June 24, 2024

To: Plan Holders for Improvements to the
KIRKSVILLE REGIONAL AIRPORT
KIRKSVILLE, MISSOURI
MODOT PROJECT NO. 24-028A-1

**ADDENDUM NO. 5
TO
CONTRACT DOCUMENTS, SPECIFICATIONS AND PLANS
FOR IMPROVEMENTS TO THE
KIRKSVILLE REGIONAL AIRPORT
KIRKSVILLE, MISSOURI
MODOT PROJECT NO. 24-028A-1**

A-521

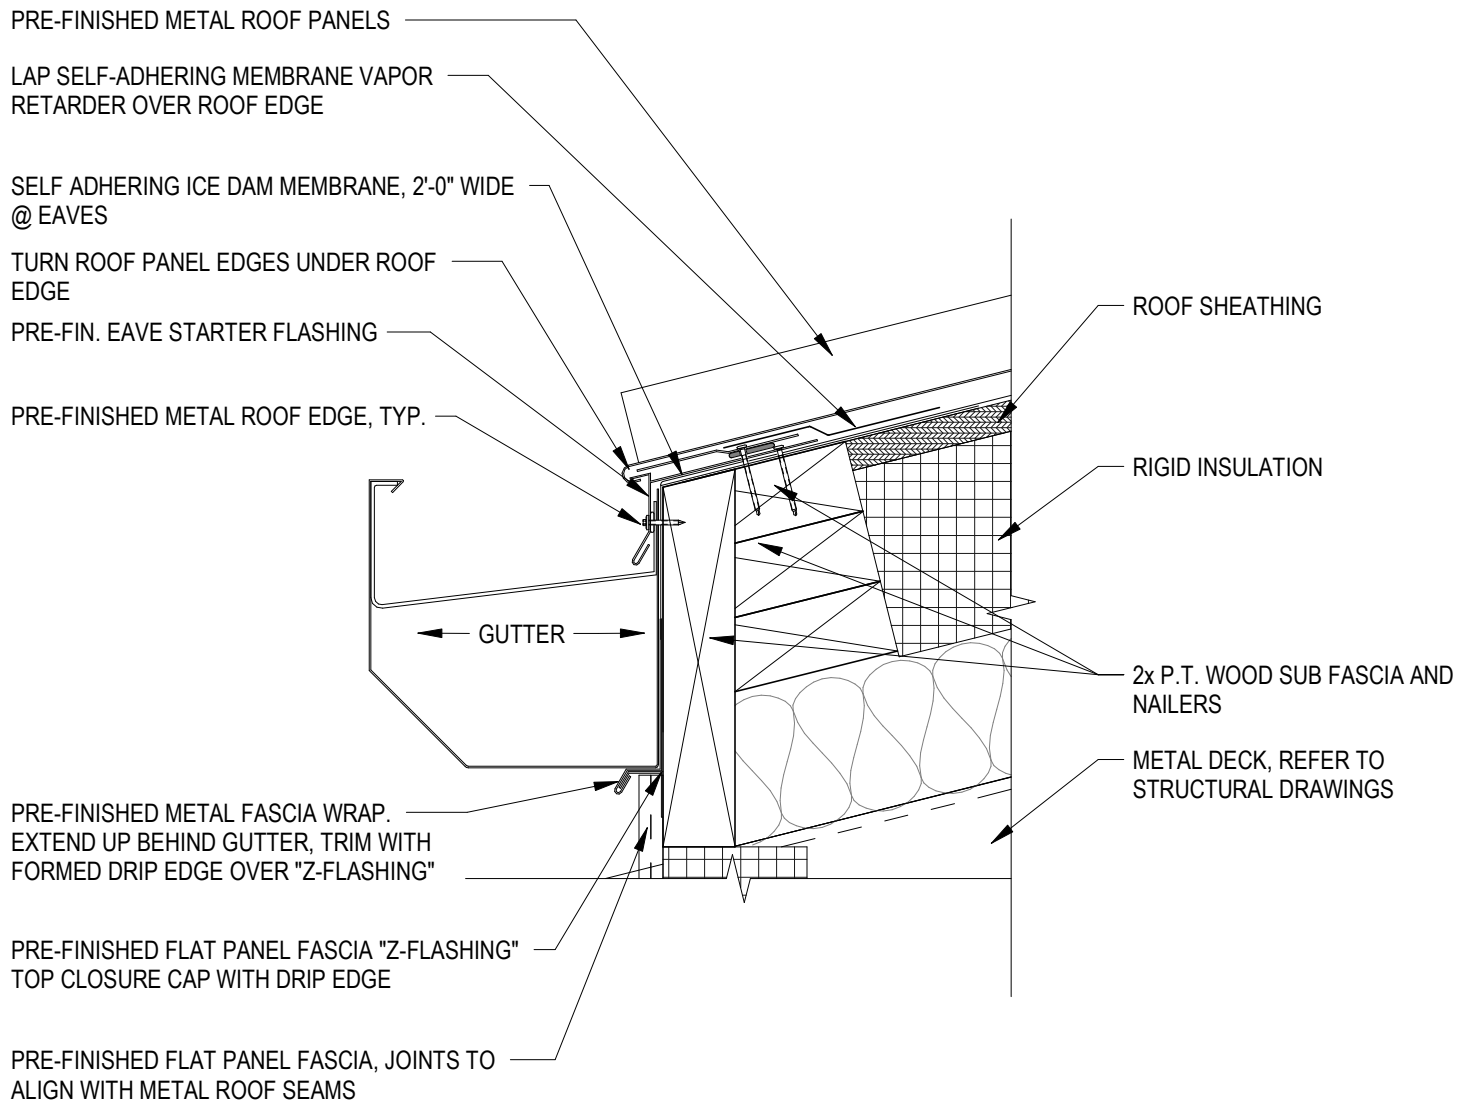
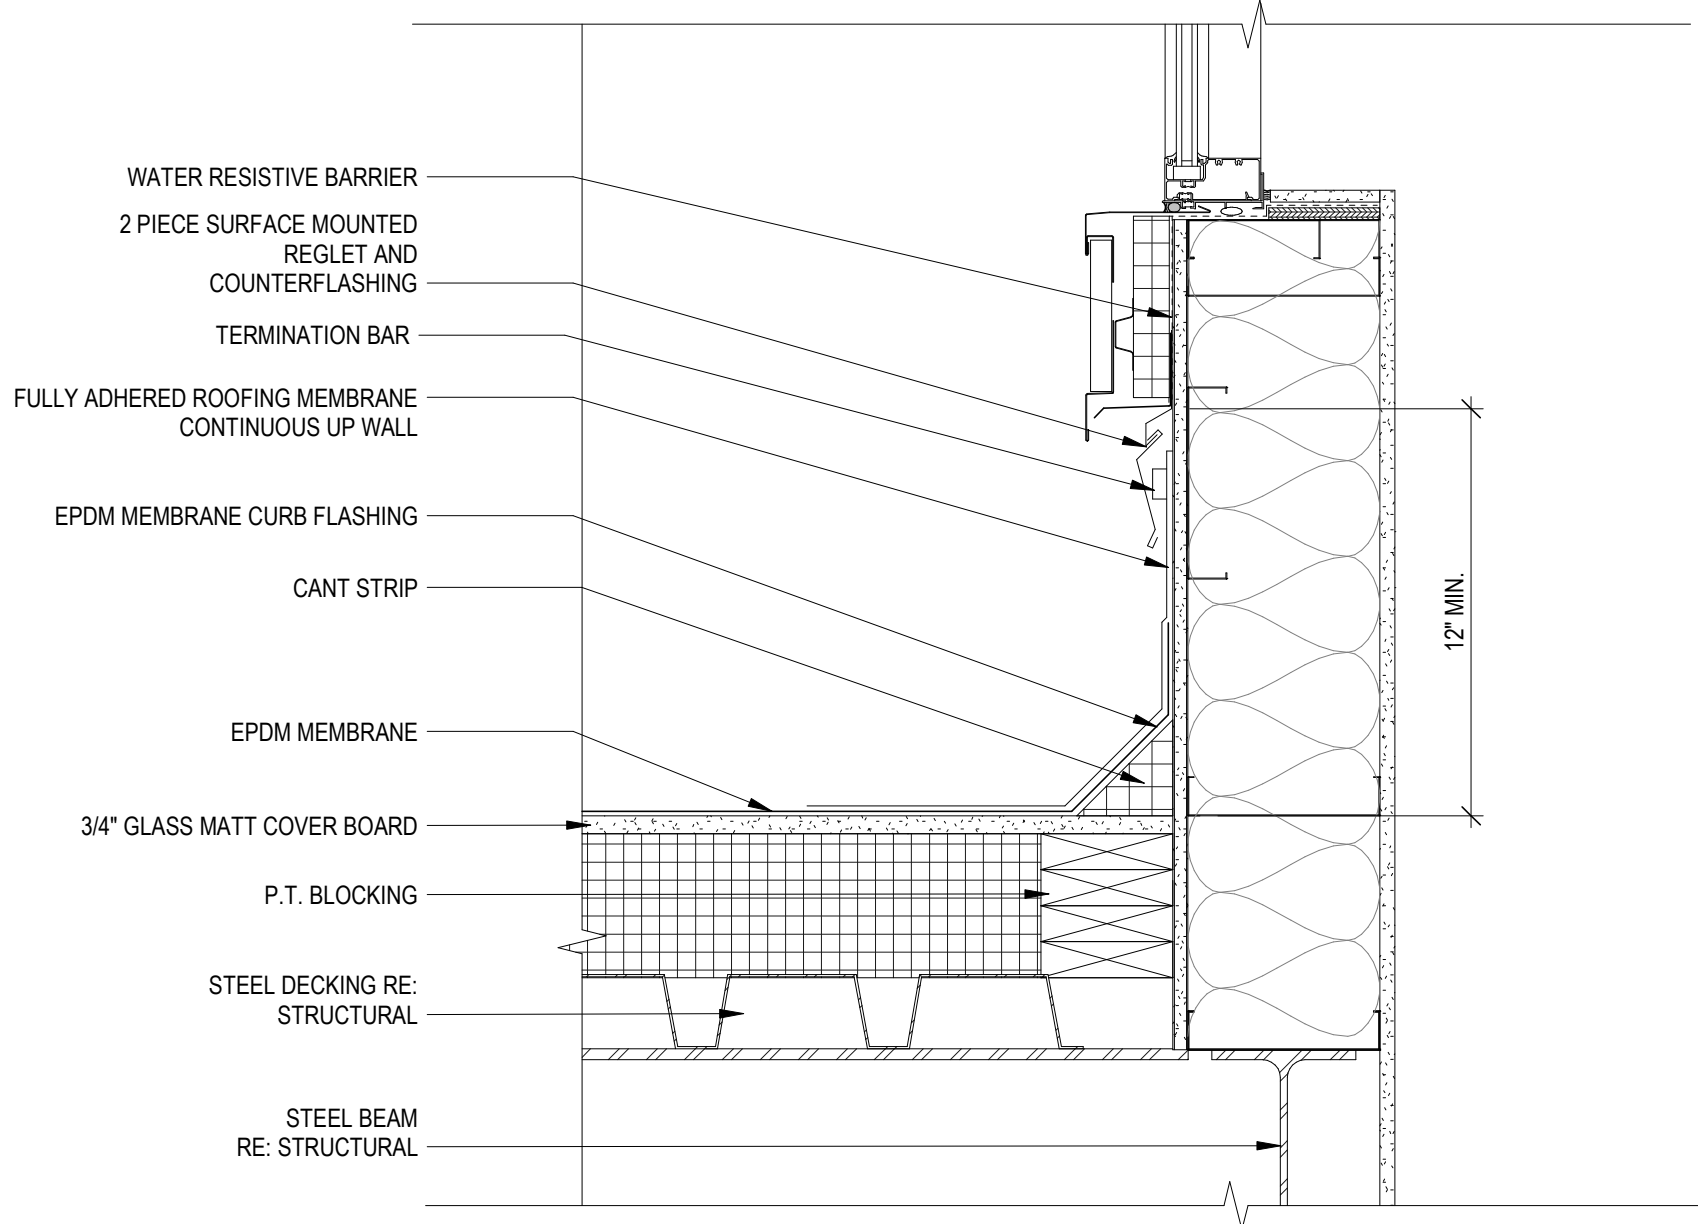
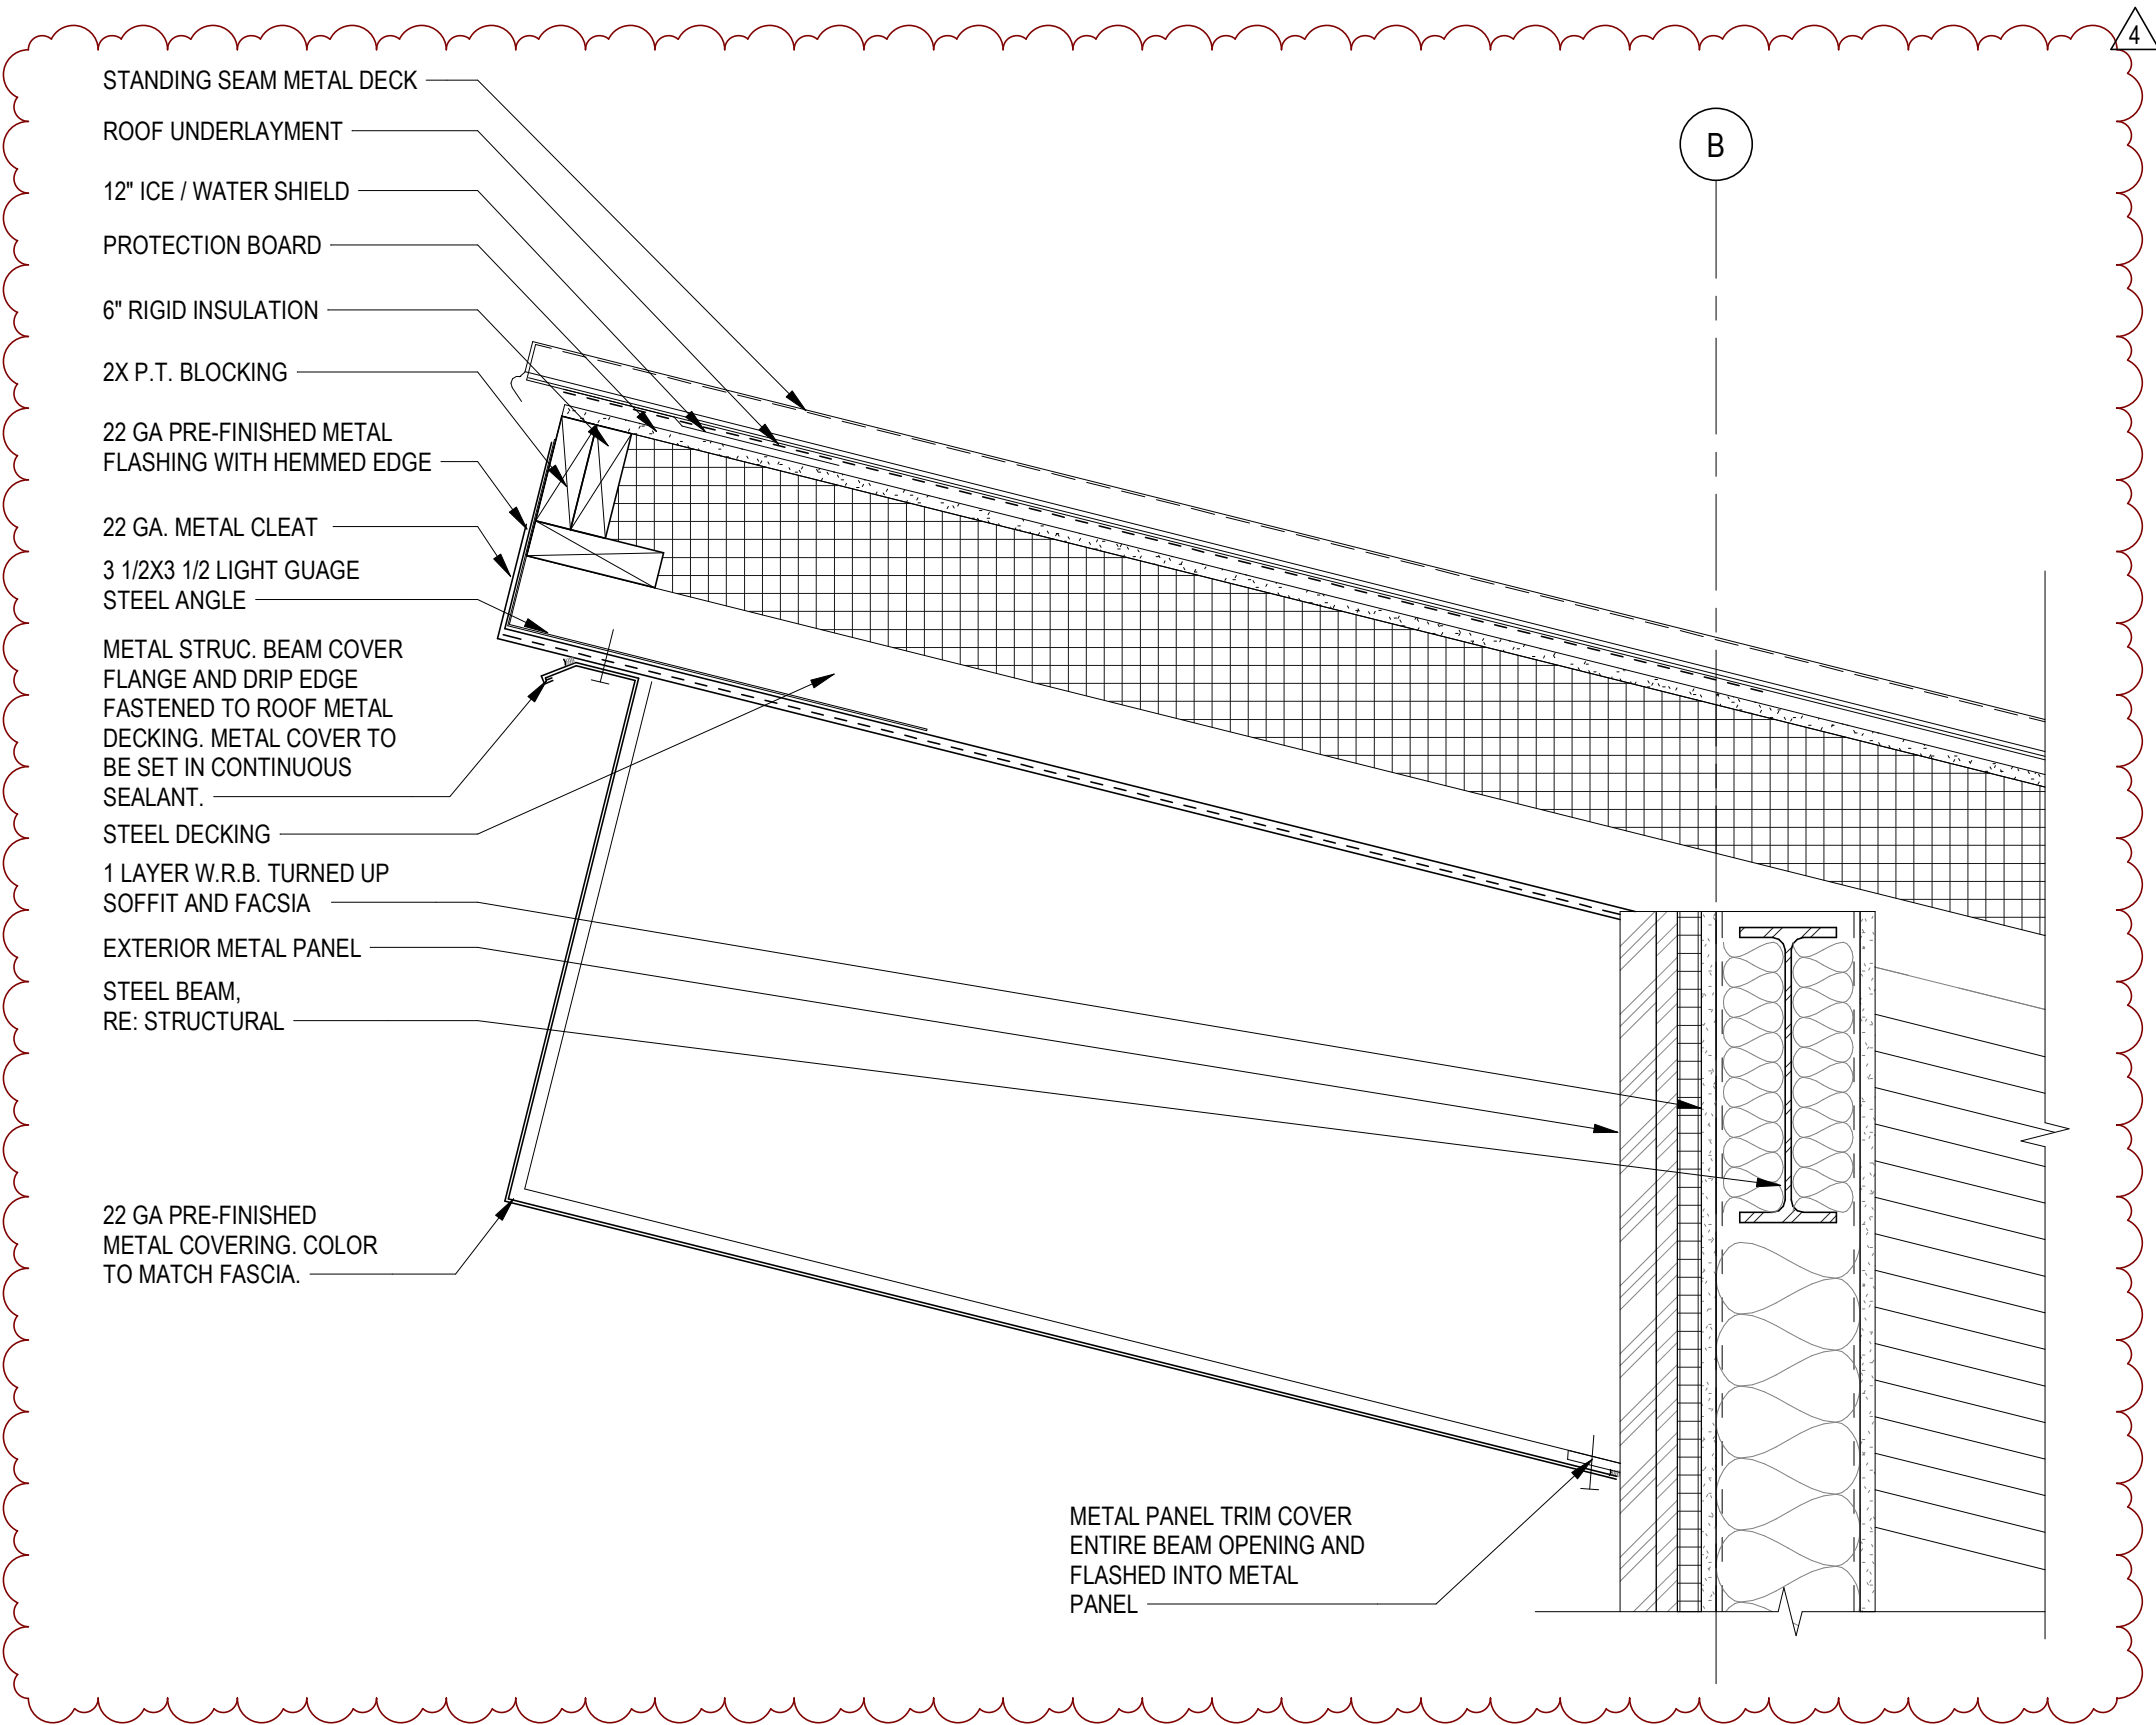
Sheet No.: A-521
Title: ROOF DETAILS
Revision: Ticket Counter details have been revised.
Justification: For clarity.
